DESIGN REVIEW BOARD FEBRUARY 15, 2019

DESIGN REVIEW BOARD JANUARY 18, 2019

5. DRB190002 217 South Main St

NORTHEAST ELEVATION

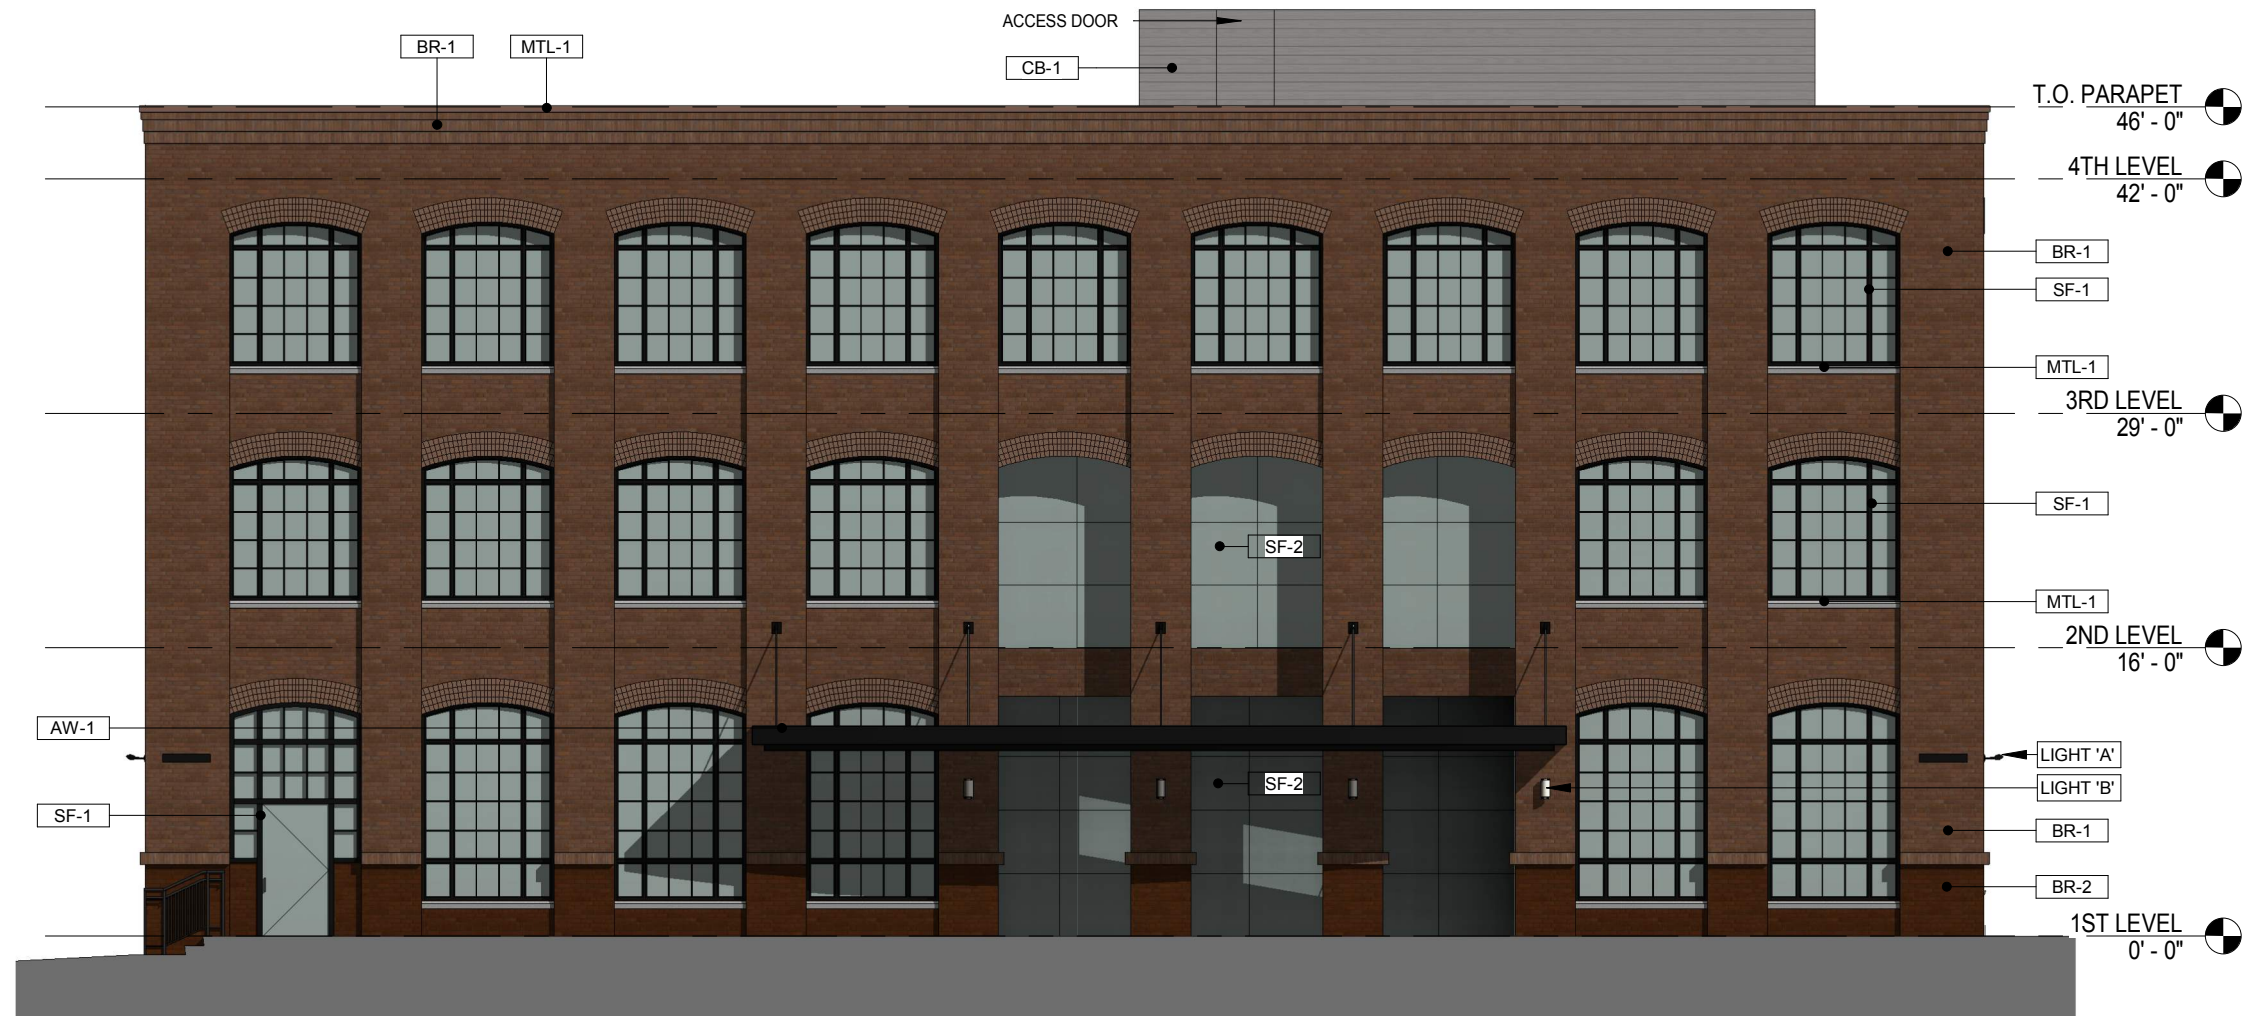
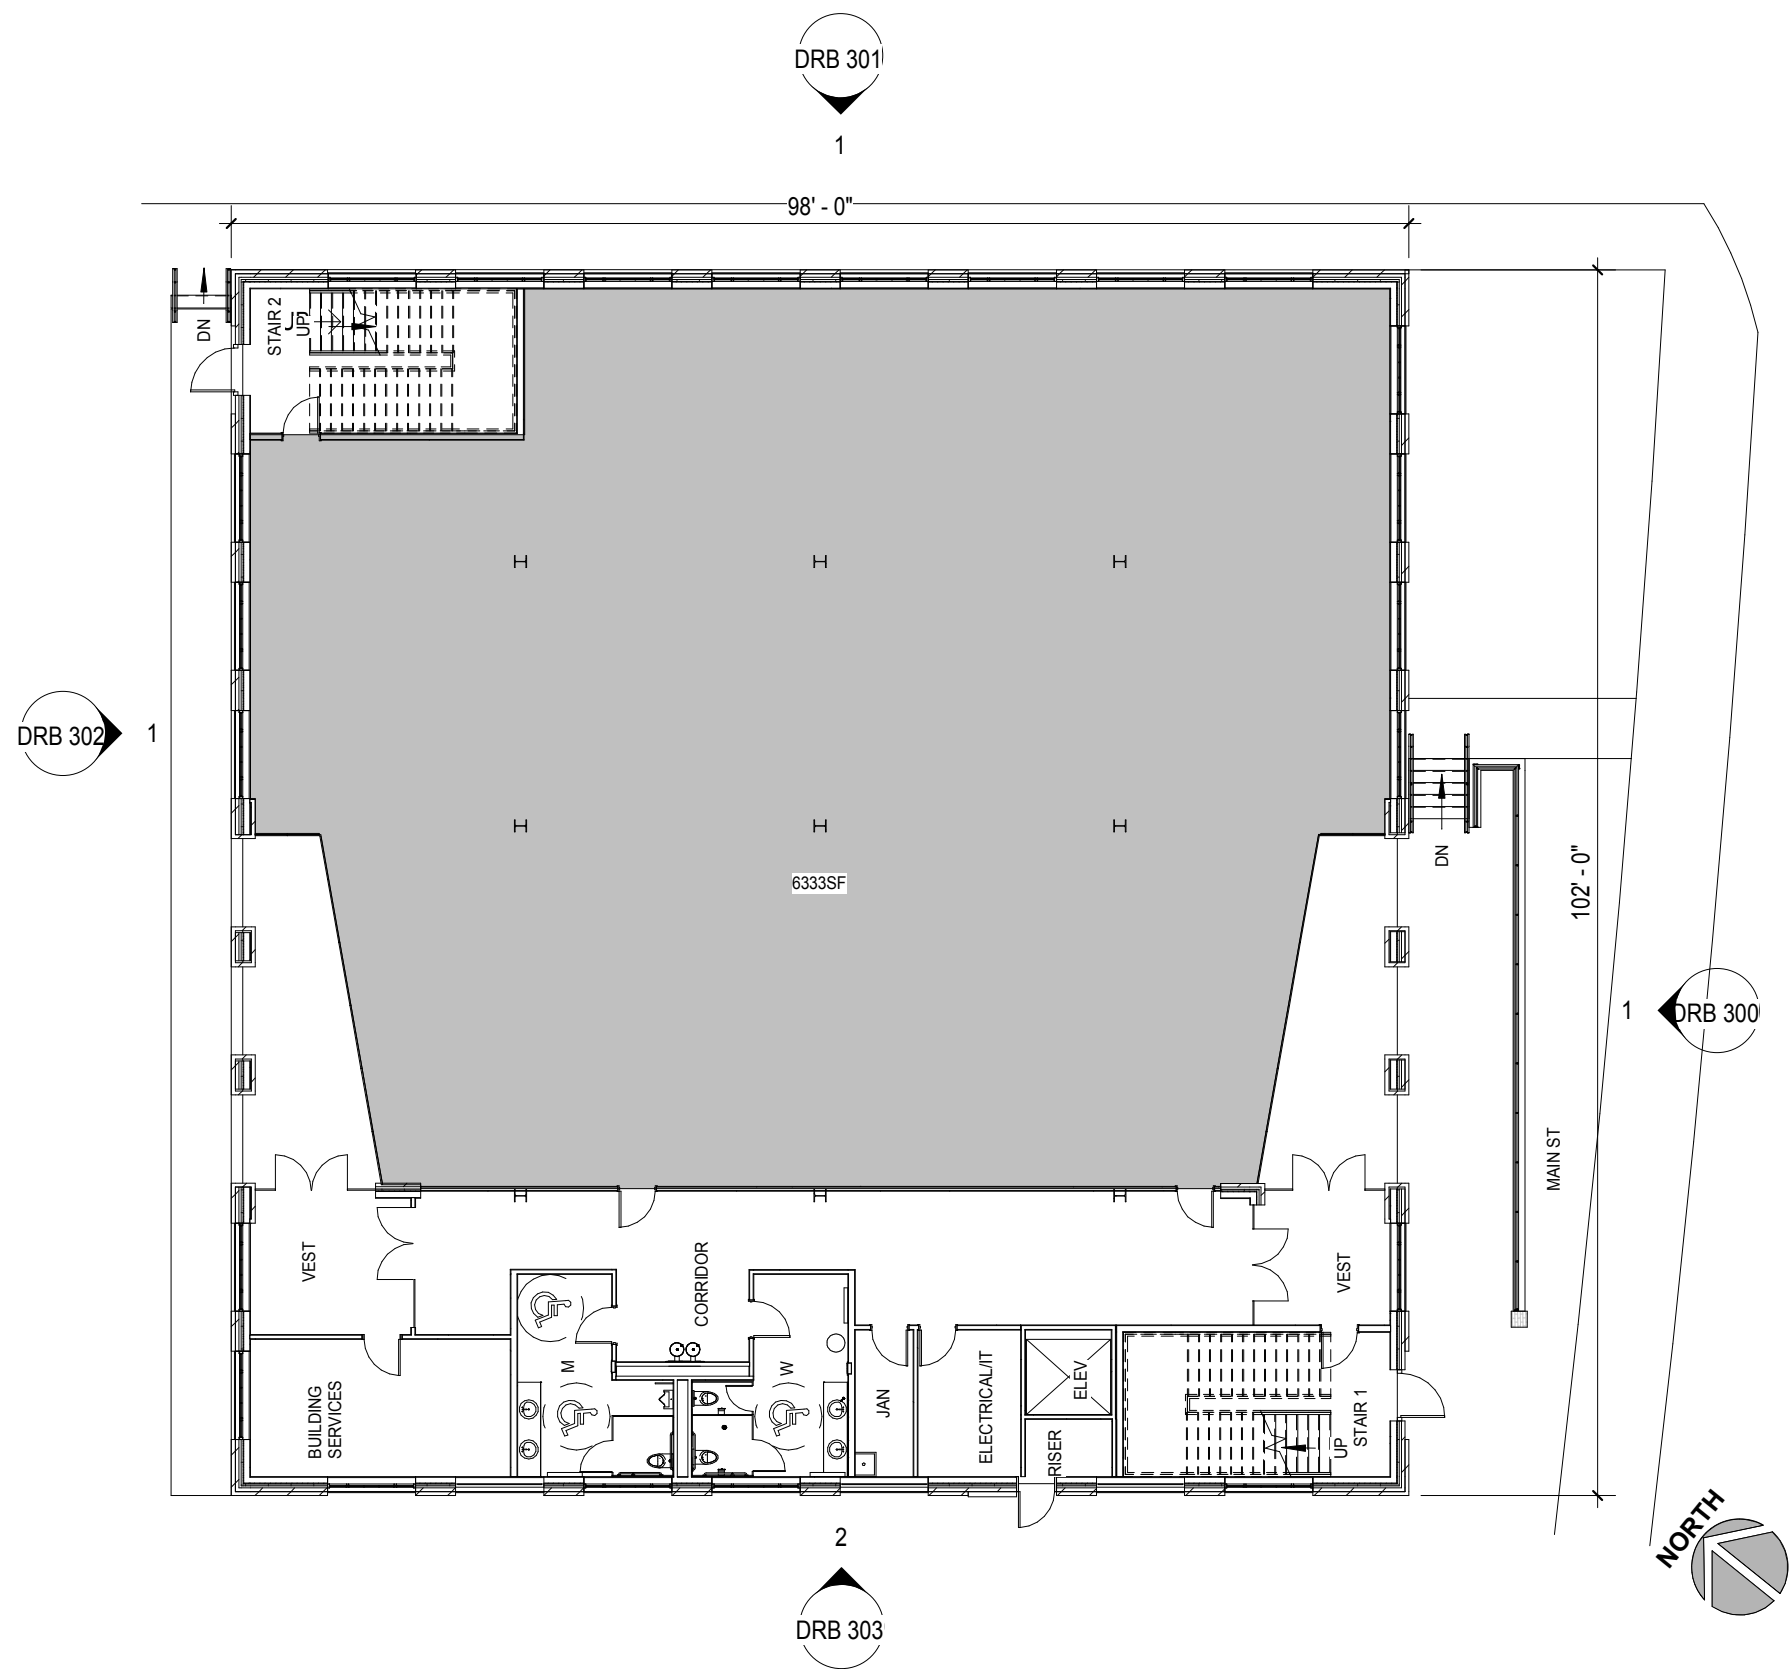
- Bricked in section to have sills, make them look like bricked in windows-adding sills or add glass where possible
- Proportion of the wall and the railing
- Minimize penthouse structure
- DRB wants to ensure that retaining wall is either brick faced or screened with vines, evergreens. DRB is very sensitive as to how it looks.

DEVORE SITE LINE STUDY

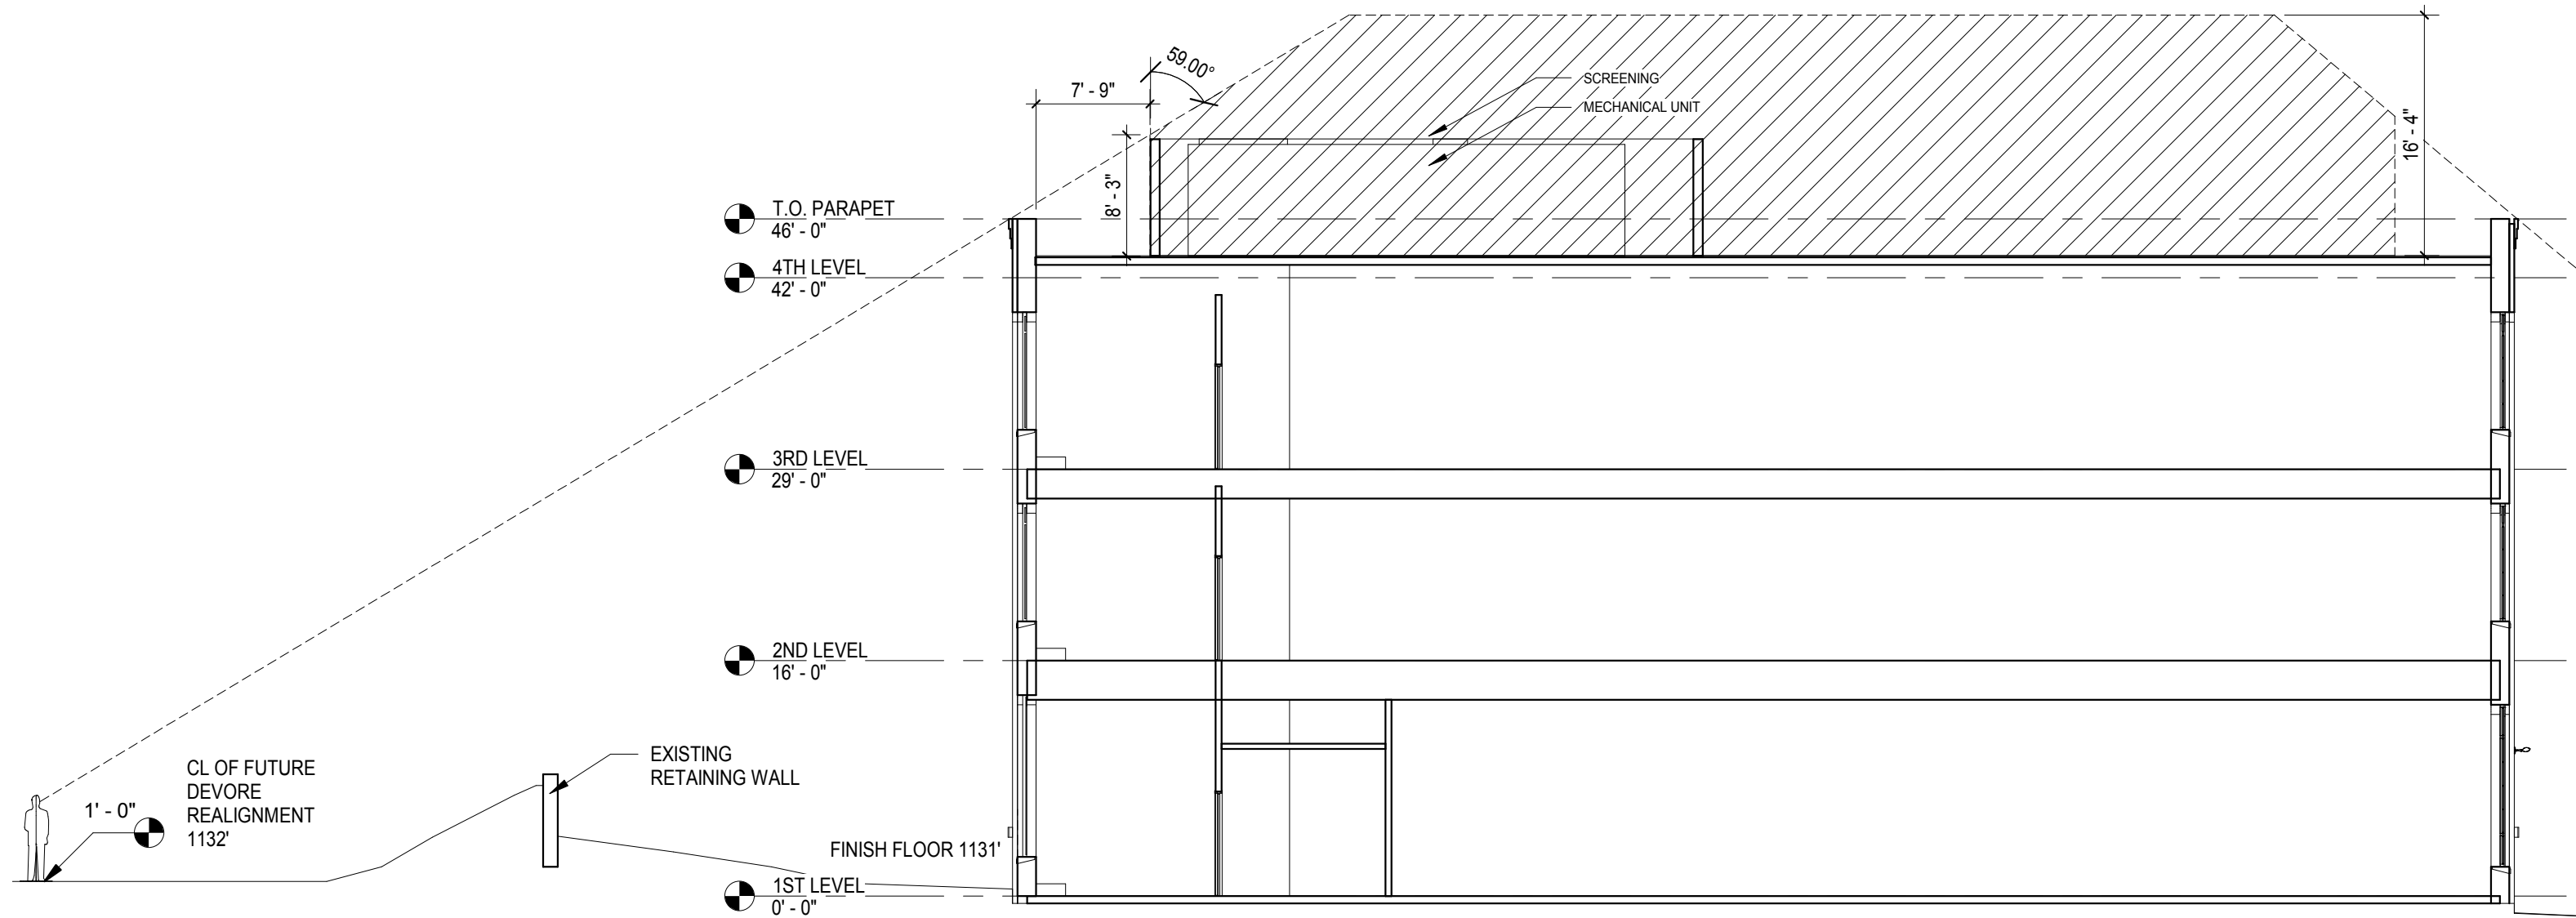
the Site Plan in concept, that we defer elevations and materials to incorporate discussion and suggestions we had today and that on Site Line that Applicant will bring back a Site Line from on South Main from the Devore side.
